CDM: Recommendation Form for Small Scale Methodologies (version 01)
(To be used for presenting questions/proposals/amendments to the simplified methodologies for small-scale CDM project activity categories)

Date of SSC WG meeting:	15–18 March 2011, SSC WG 30
Title/Subject (give a small title or specify the subject of your submission, maximum 200 characters):	Clarification on the calculation of <i>ex post</i> baseline emissions under AMS-III.I
Indicative methodology to which your submission relates (refer the items of Appendix B of the Simplified Modalities and Procedures), if applicable.	AMS-III.I “Avoidance of methane production in wastewater treatment through replacement of anaerobic systems by aerobic systems”
Name of the authors of the query:	Florian Eickhold Institution: Greendevlopment S.A. f.eickhold@greendevlopment.com.gt

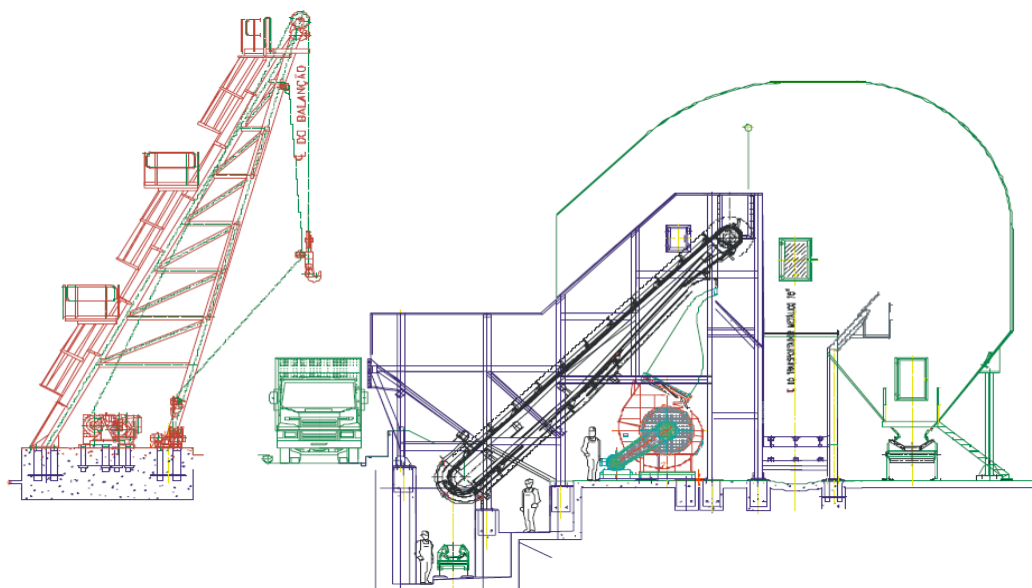
2. To enable a better understanding of your issues, please provide more details on the improved project system, as mentioned in “As well, the improvement of the system involves adding new technology to the cleaning process to drastically reduce water consusketch/picture may be used.

The following sketch shows the “cleaning table” which cleans the cane with air instead of water. For further detail, see the description of the applied technology in answer 1. The cleaning table is only a minor part of the project activity improving the overall wastewater system.

The SSC WG recognized that the proposed project activities involve changes of processes which will impact the source and characteristics of the wastewater generation. In such a context, the SSC WG is of the opinion that the proposed approach may not representatively reflect the baseline situation and thus may not lead to a conservative emission reductions determination, because:

- The replacement of water cleaning process by a dry cleaning process may have direct impact on other parts of the sugar cane processing plant, i.e. the energy consumption in milling, crushing, processing of sugar cane may change. In addition, it may also have an impact on the yield and quality of the product and co-products (e.g. bagasse). In other words, the proposed technology/measure implies in an expansion of the project boundary, to cover not only the wastewater treatment plant, but also the industrial process;

- Any increased emissions because of the implementation of the project activities shall be taken into account, e.g. possible increased energy consumption by the dry cleaning section shall be considered, including the eventually needed thermal energy for hot air generation, exhaust gas cleaning, and mechanical devices.
